161-04355-WFC, CAM
December 24, 1991

Replace with revised Figure 3.2-2

RELOAD ANALYSIS REPORT FOR
PALO VERDE NUCLEAR GENERATING STATION UNIT 1
CYCLE 4

FIGURE 3.2-2

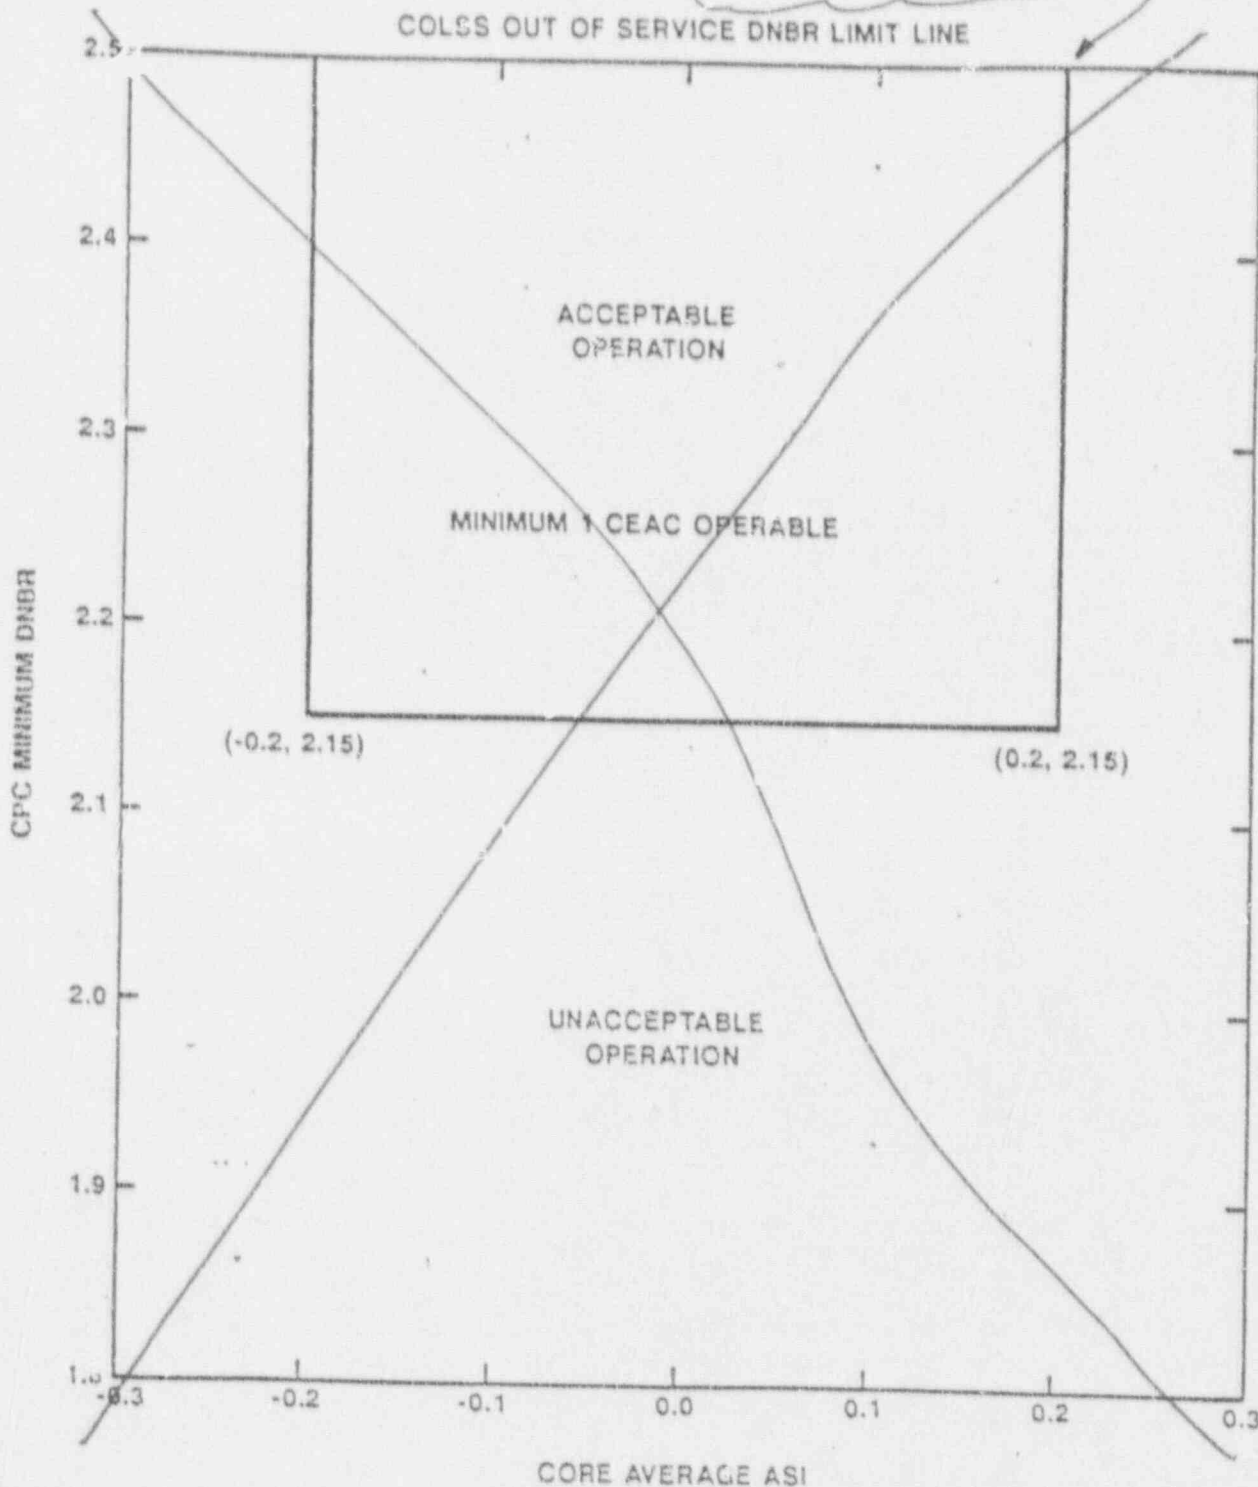
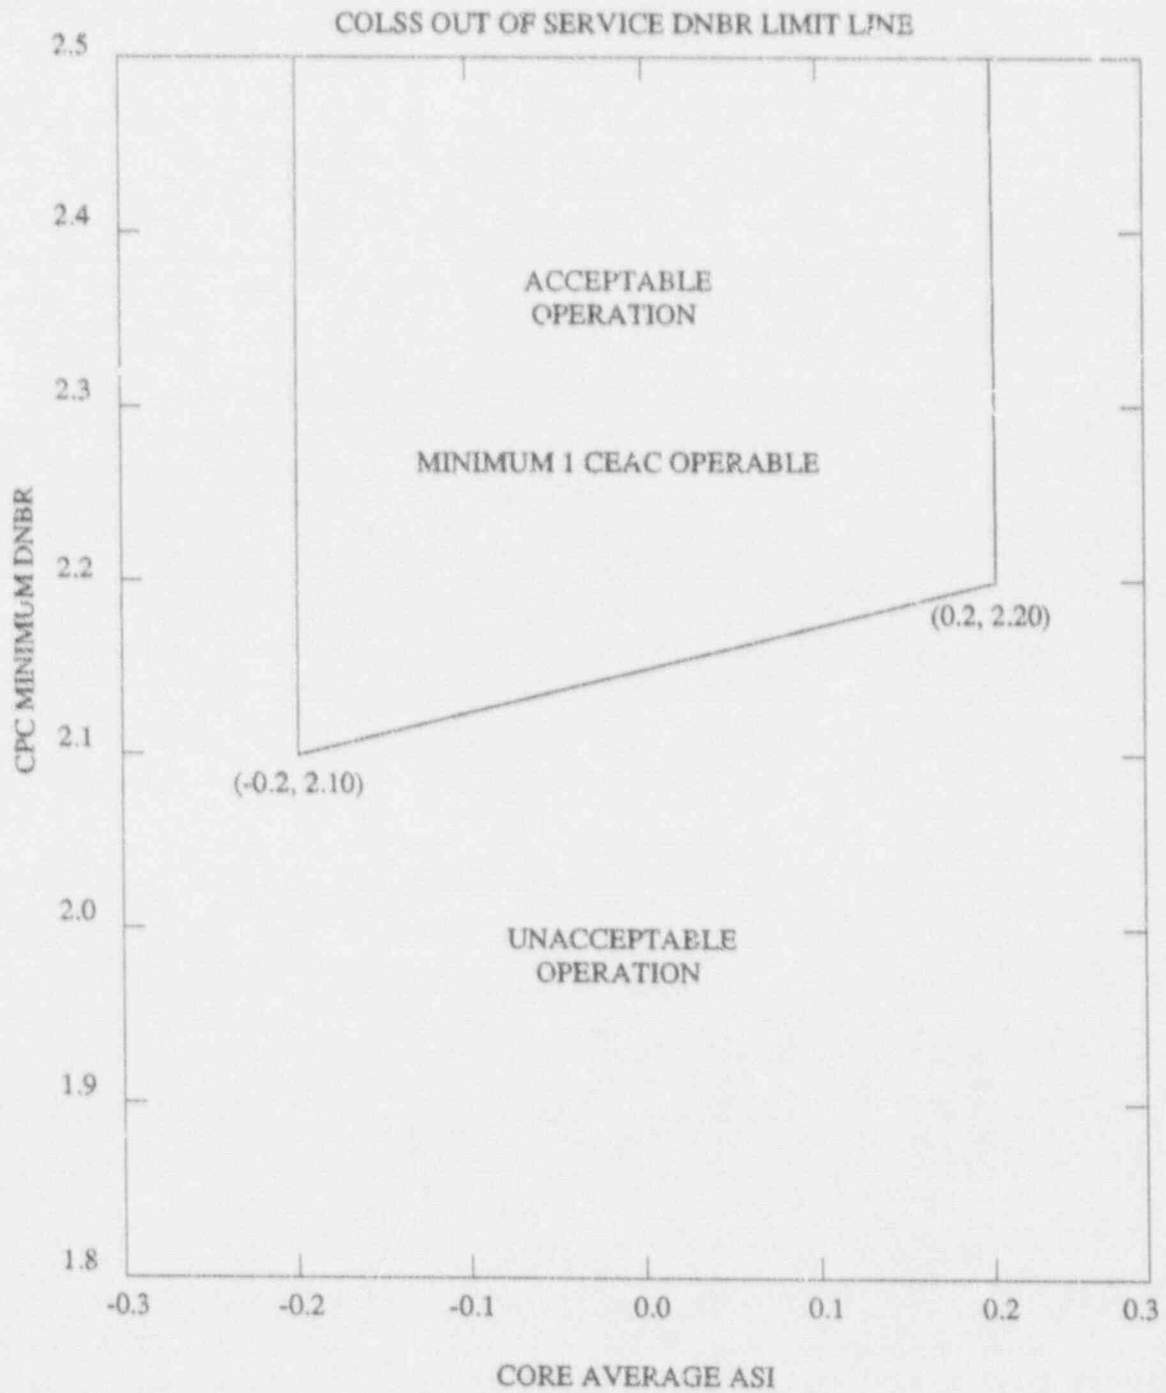
Revise Figure 3.2-2, COLSS out of service DNBR limit line - CEACs operable and Figure 3.2-2A, COLSS out of service DNBR limit line - CEACs inoperable to reflect Cycle 4 core characteristics.

FIGURE 3.2-2a
DNBR MARGIN OPERATING LIMIT BASED ON CORE PROTECTION CALCULATORS
(COLSS OUT OF SERVICE, CEAC'S INOPERABLE)

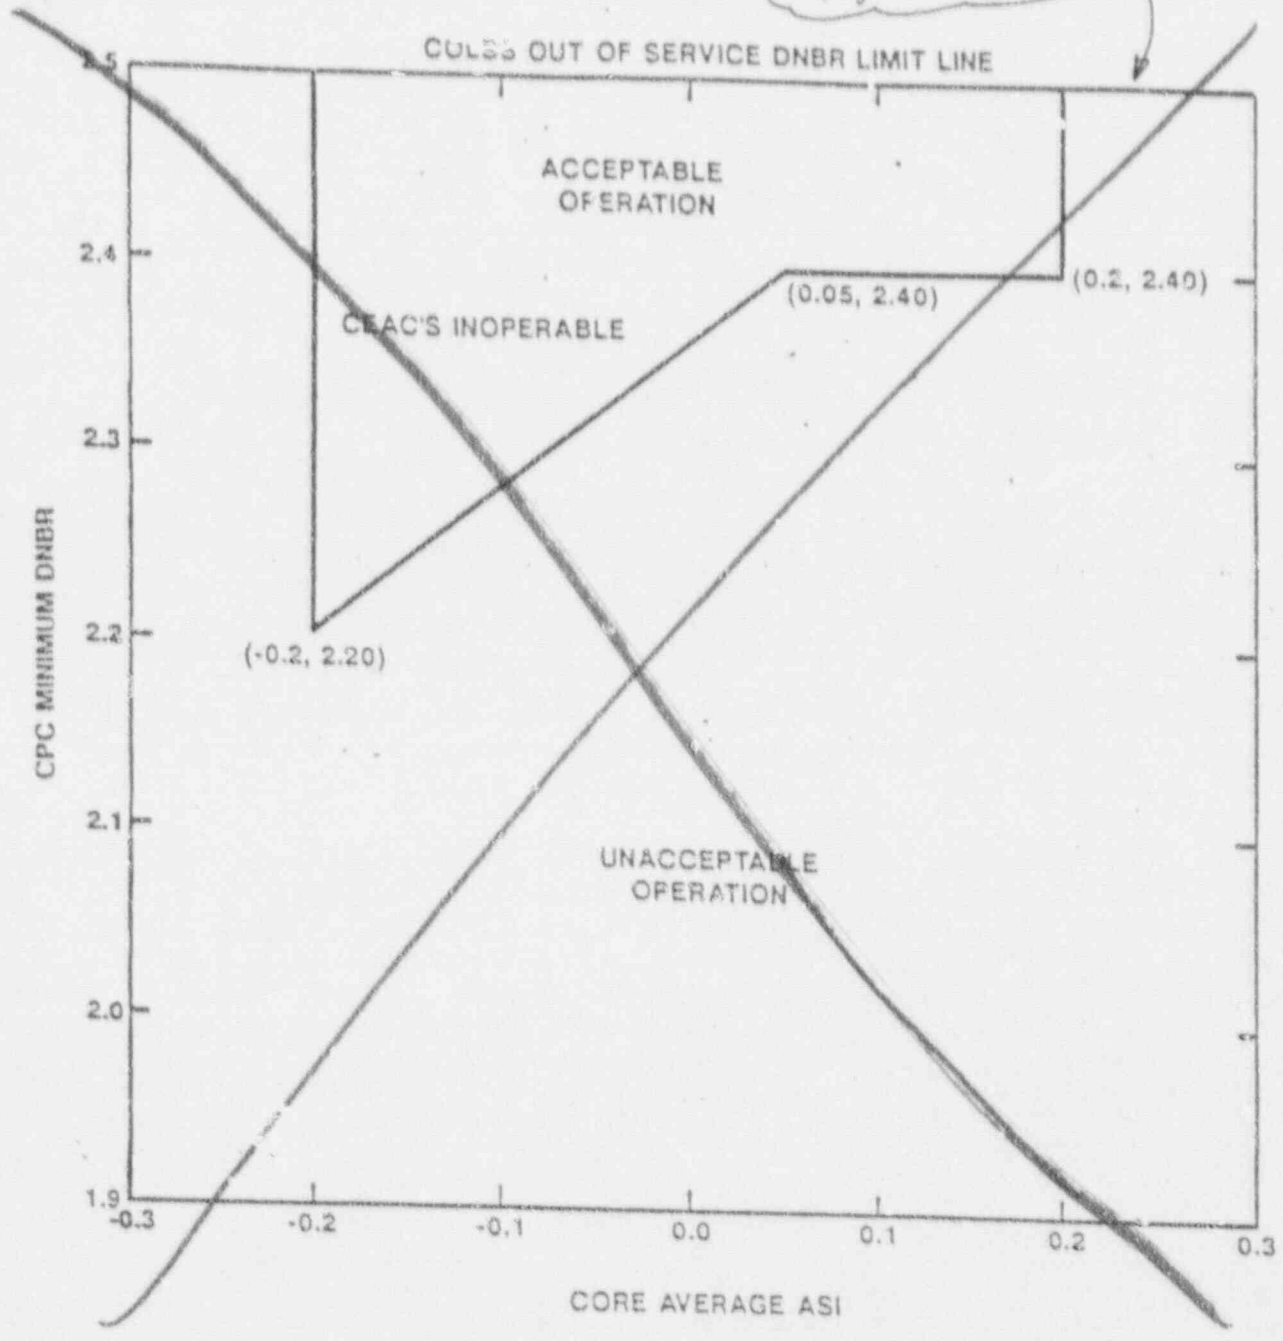
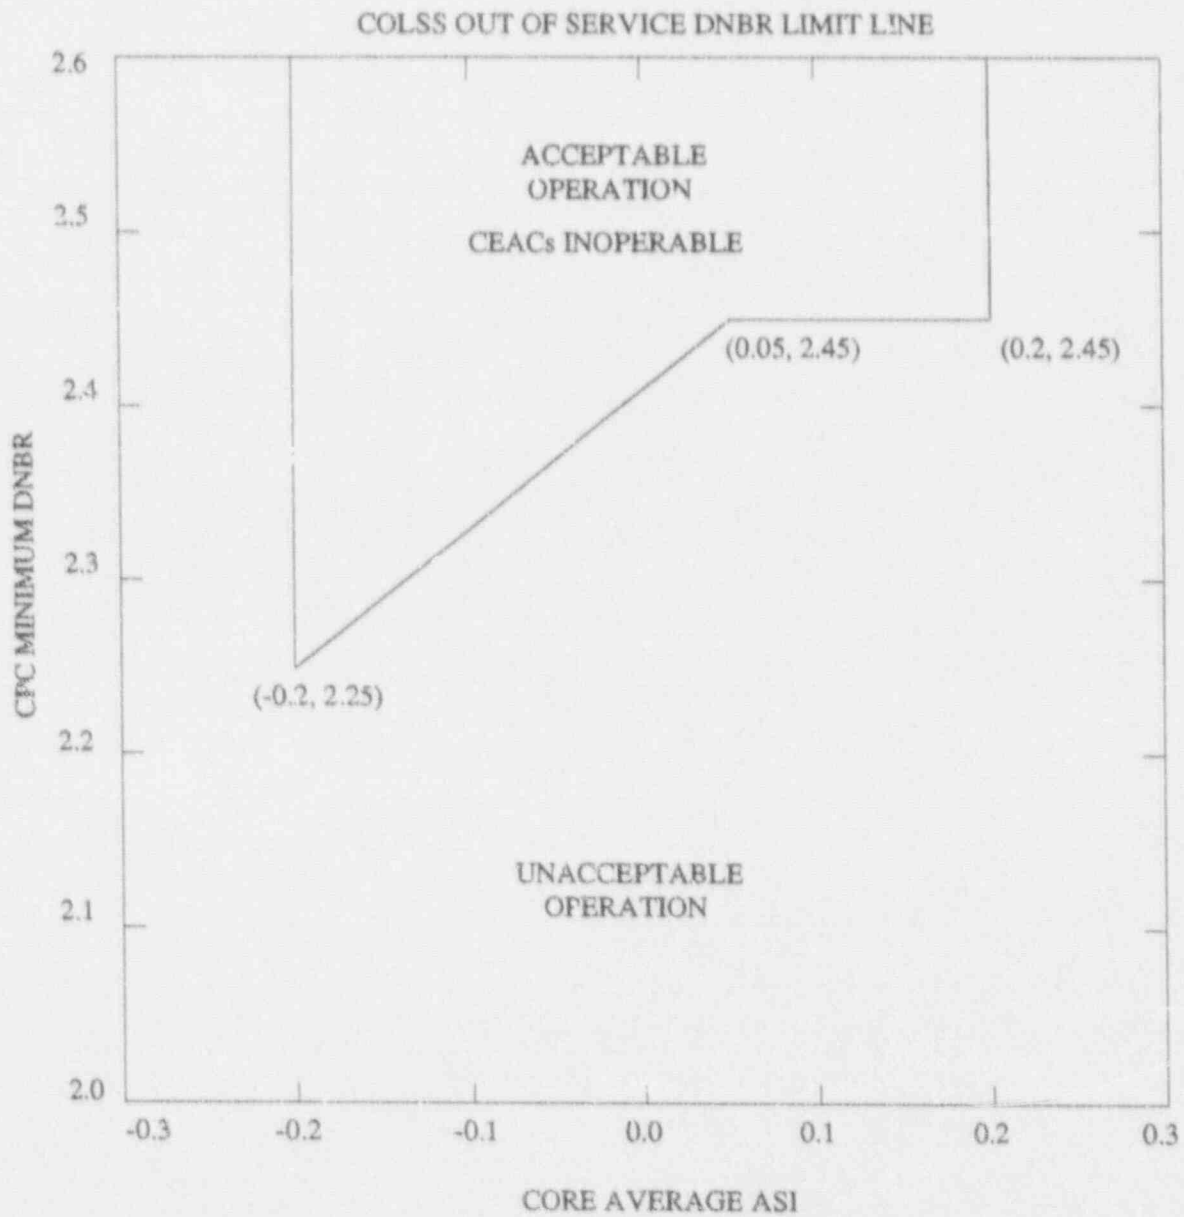
Replace with revised
Figure 3.2-2a
